**DUKE POWER COMPANY
NUCLEAR GENERATION DEPARTMENT**

**ODCM
OFFSITE DOSE CALCULATION
MANUAL**

Subject: Offsite Dose Calculation Manual (ODCM)
Generic Section - Revision 43

JUSTIFICATION FOR REVISION 43

GASEOUS WASTE SYSTEM
 OCONEE NUCLEAR STATION
 FIGURE A1.0-2
 PAGE 1 OF 4

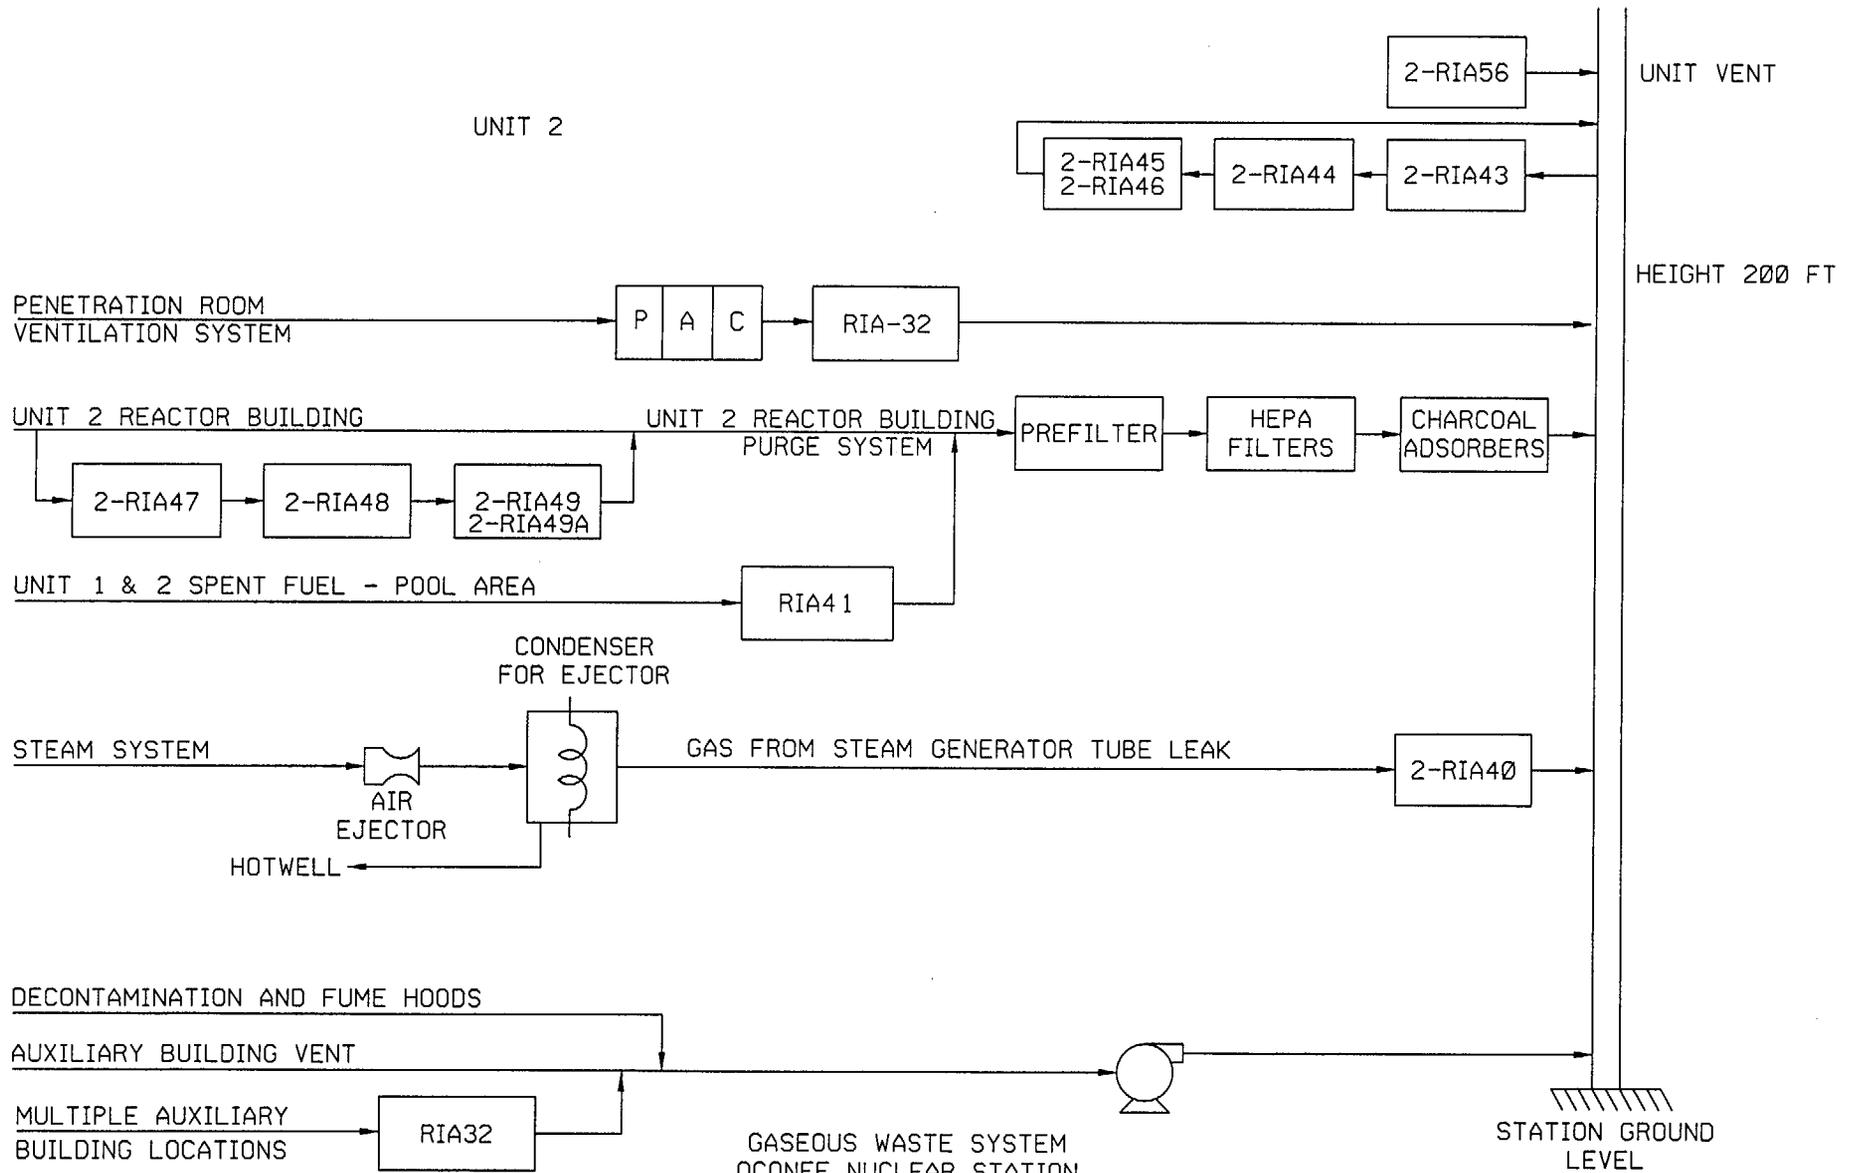
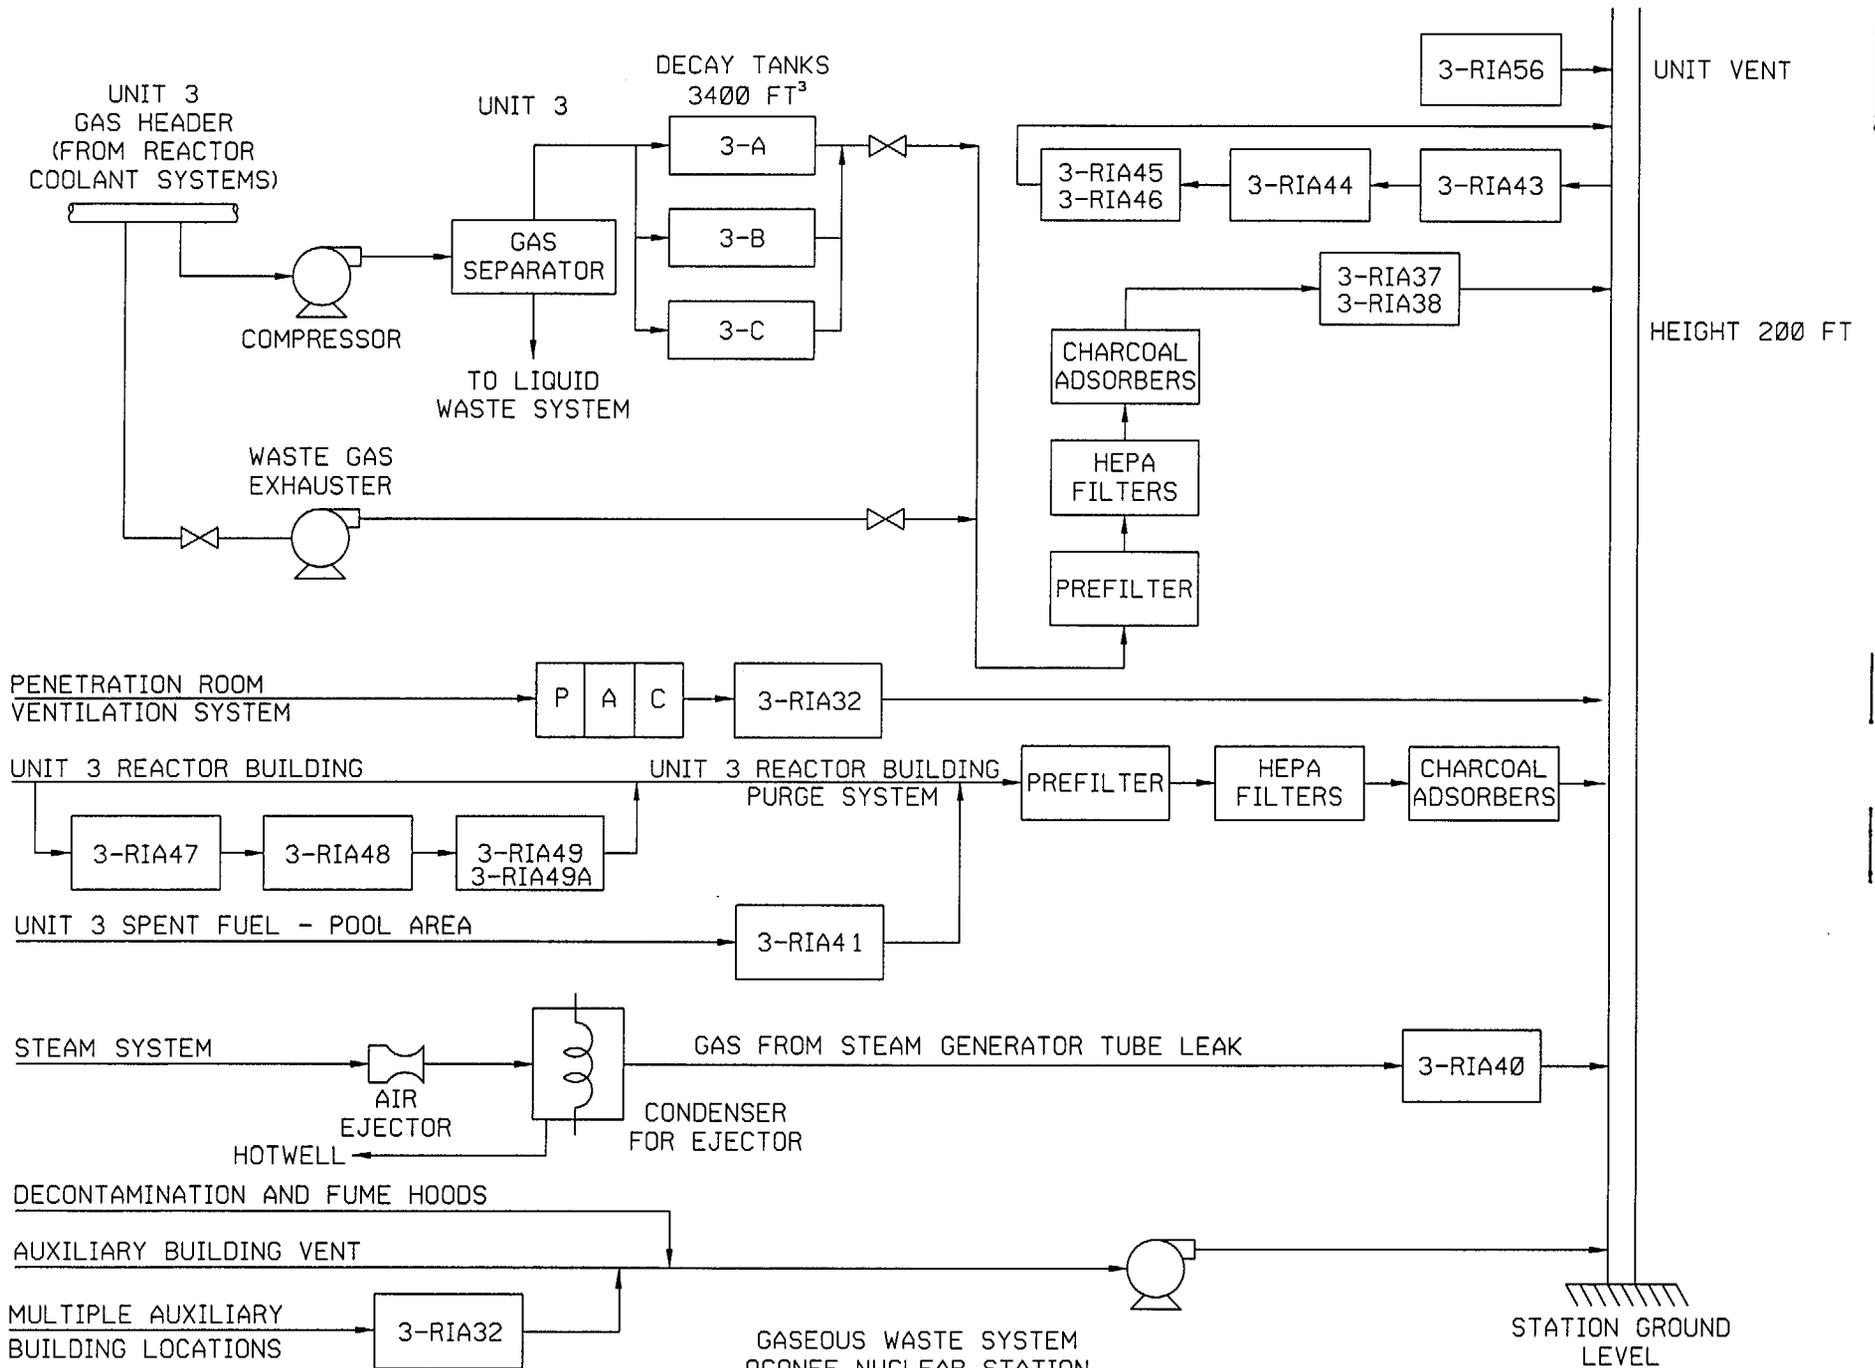
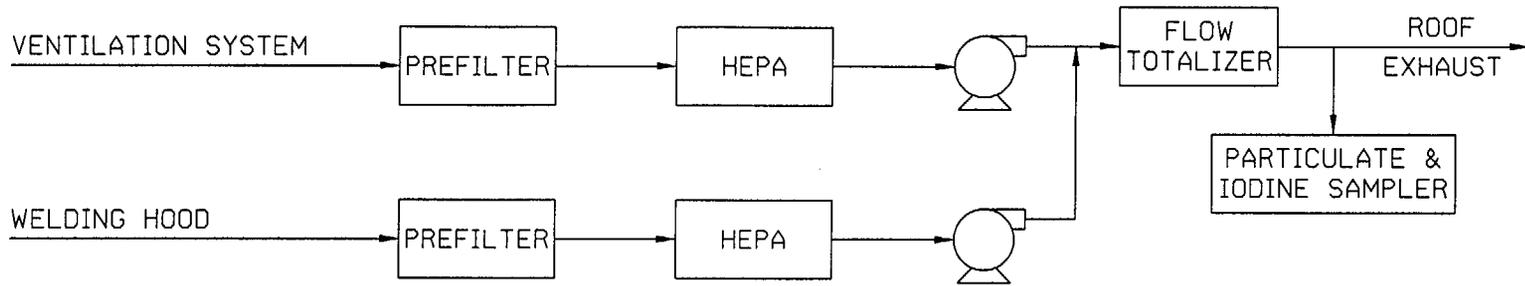
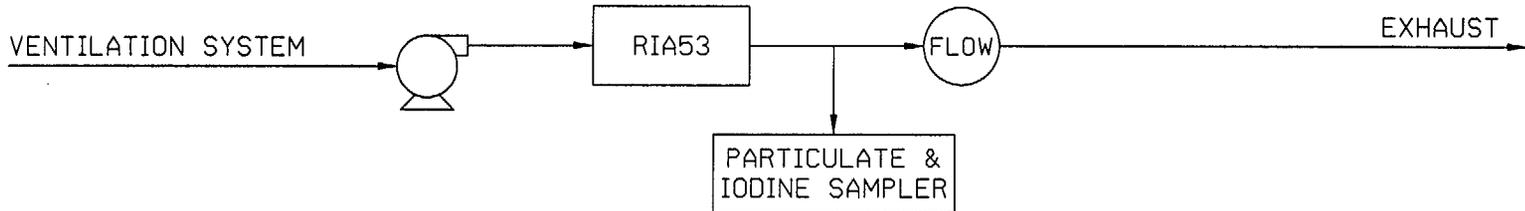
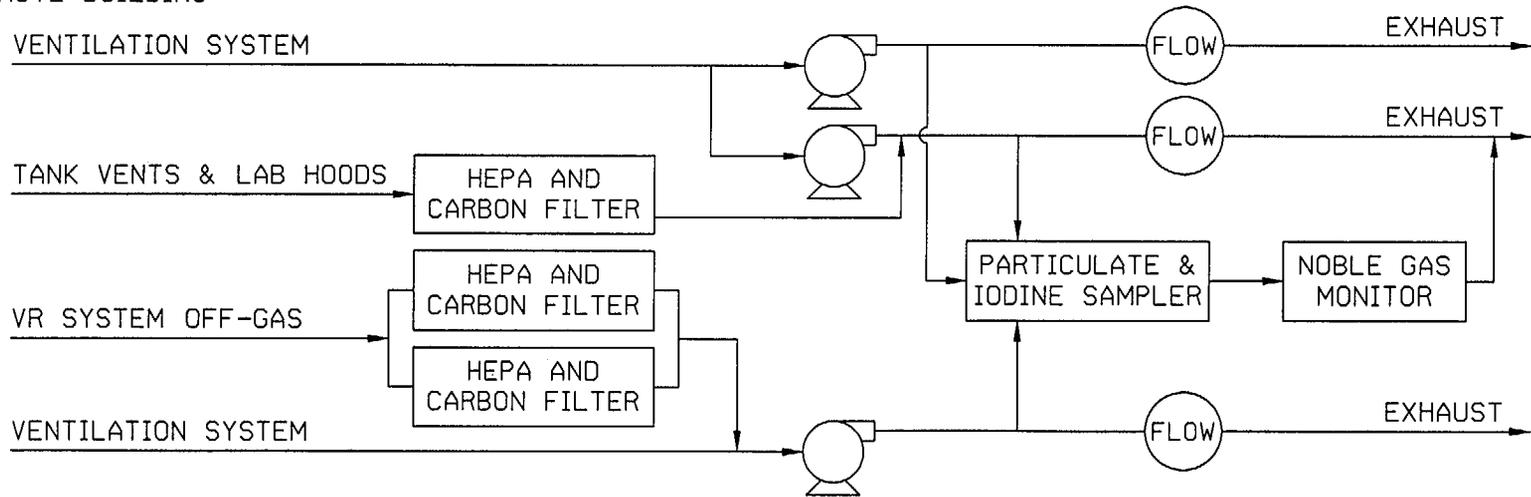
Figure A1.0-2 (four pages)

Monitor designations updated to reflect current design. Monitor changes were due to recent modifications to the plant radiation monitoring system. RIA-49A on each of the 3 Units was added during the modification. Units 1&2 RIA-32 replaced 1 RIA-51 and 2 RIA-51, and Unit 3 RIA-32 replaced 3 RIA-51. RIA-56 on all 3 Units monitors the Unit Vent directly, rather than through an off-line process as had been indicated in the previous figures. The Interim Radwaste Facility ventilation system exhaust is monitored by a flow rate measuring device, rather than a flow totalizer as had been indicated in the previous figure.

Figure B5.0-1
 (2 of 2)
 Revision 38
 1/1/97

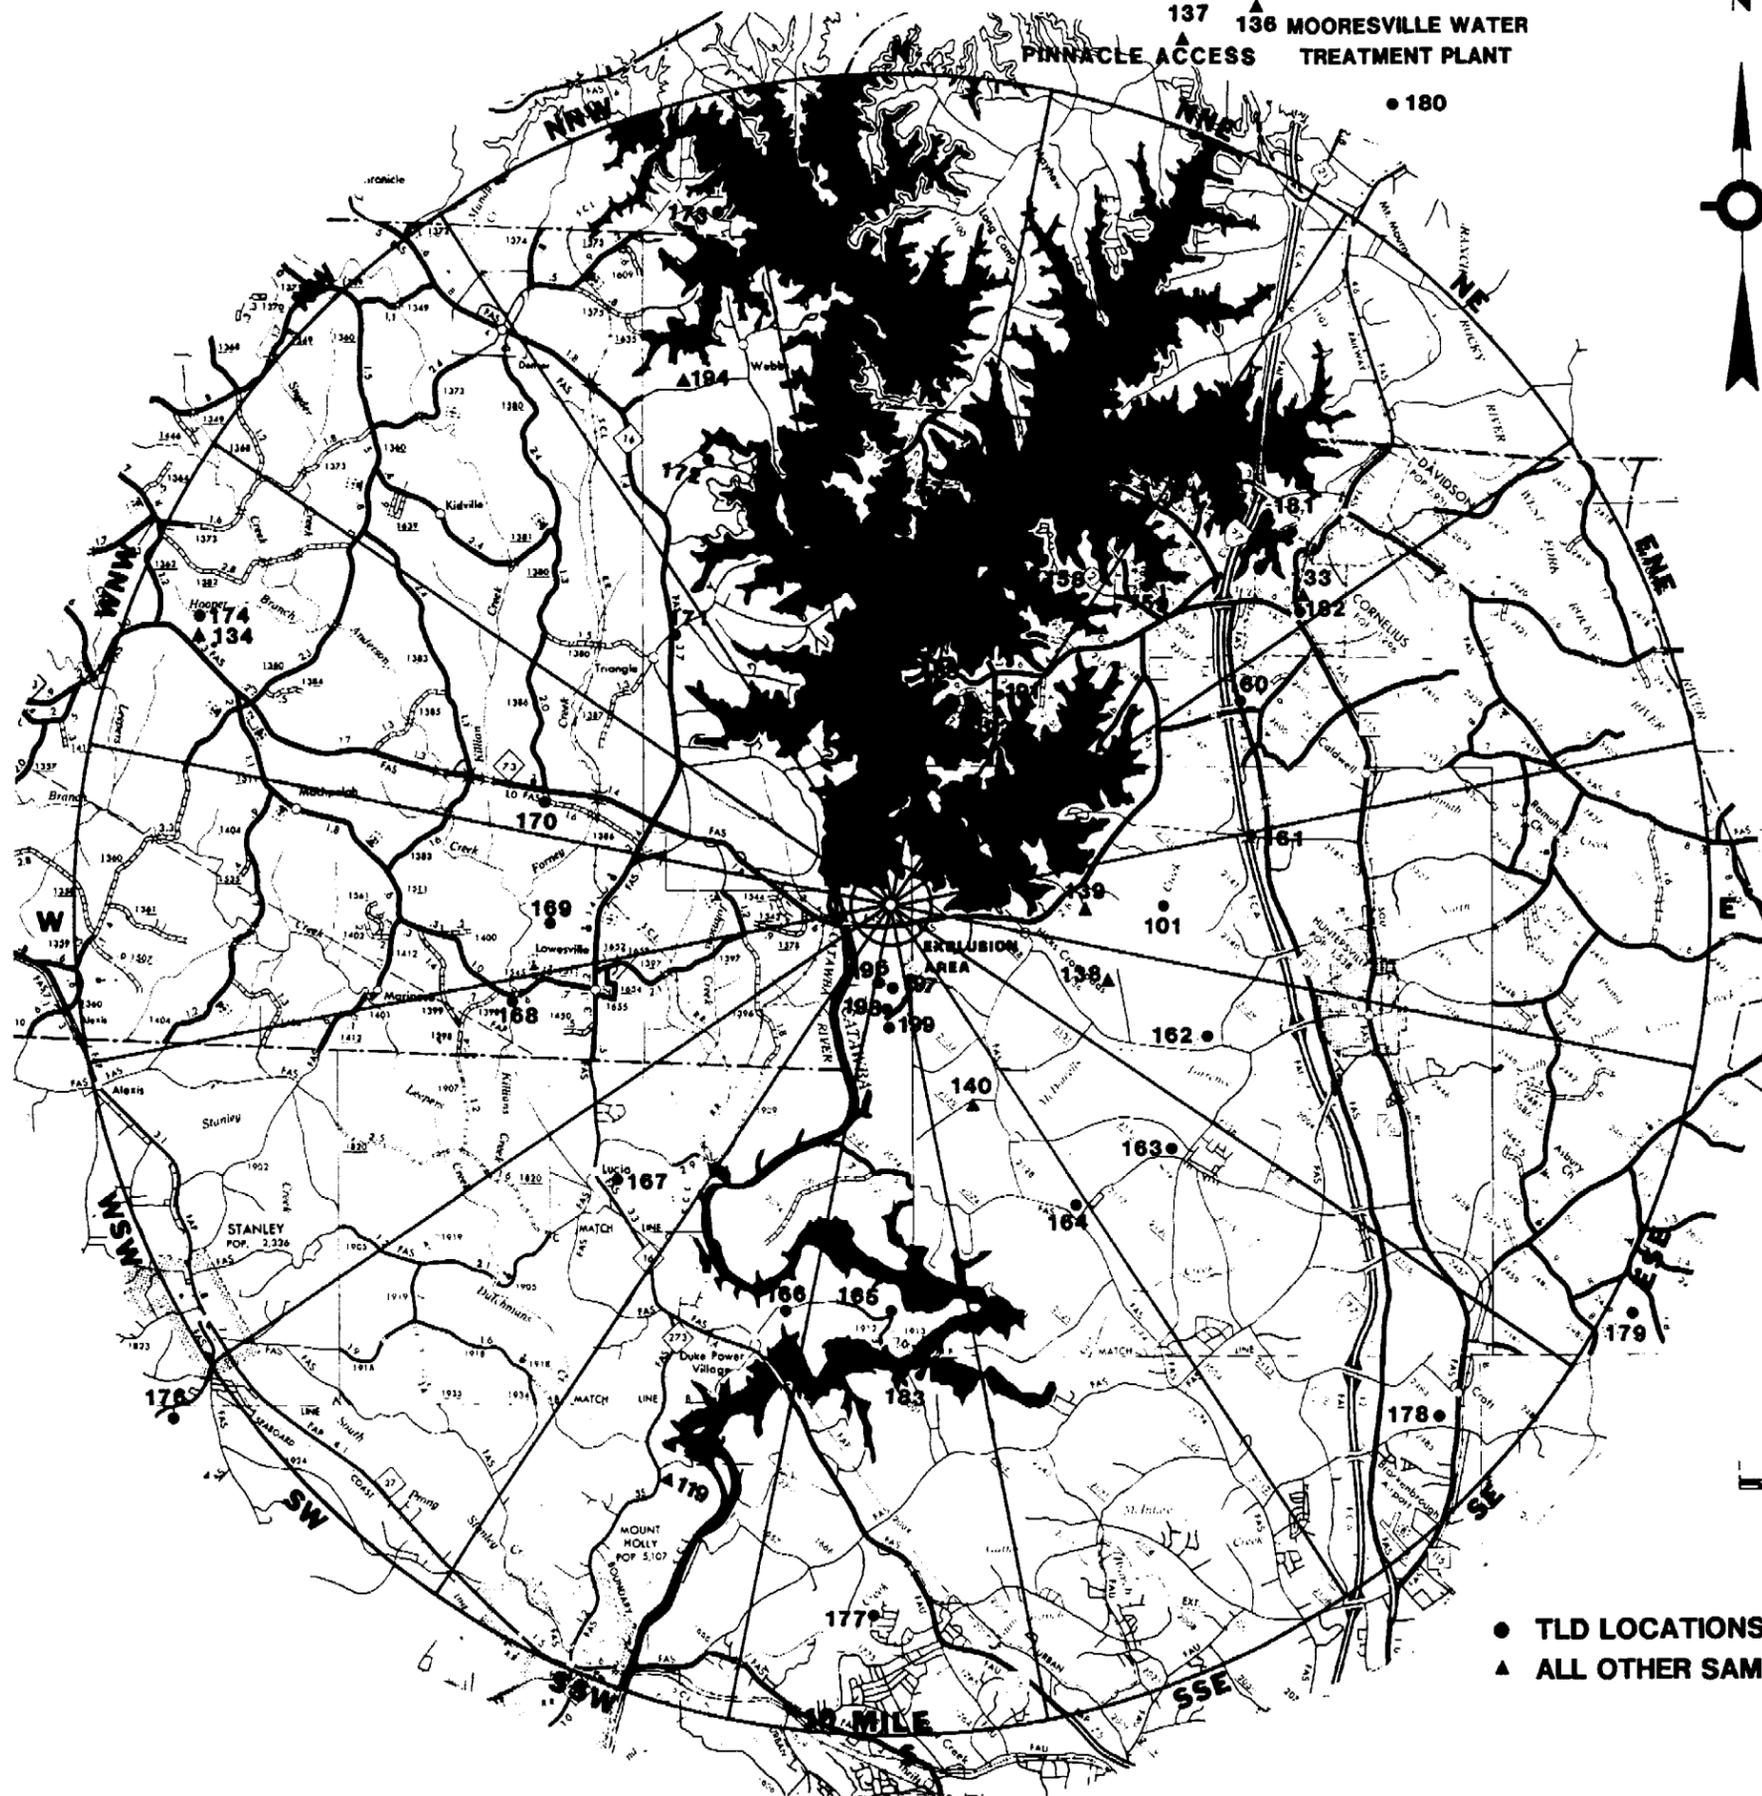
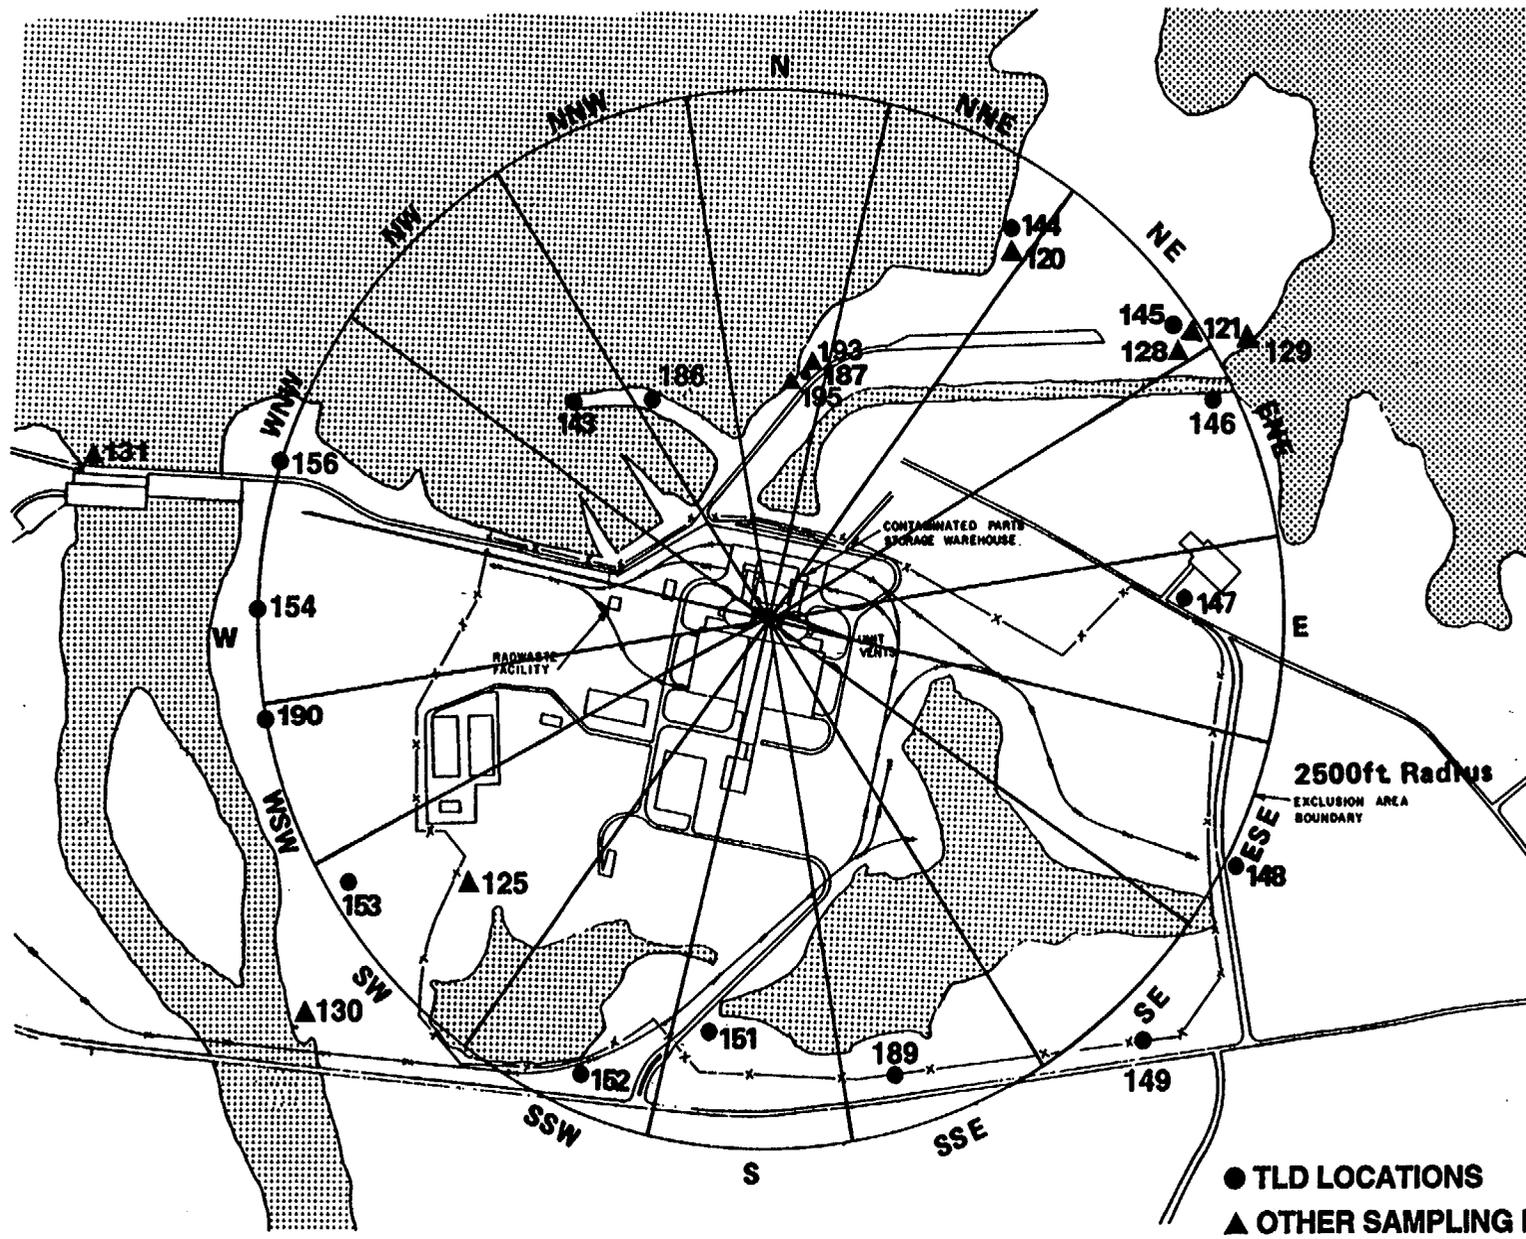
Figure B5.0-1 (page 1 of 2)

Added North Mecklenburg Drinking Water Site #101.
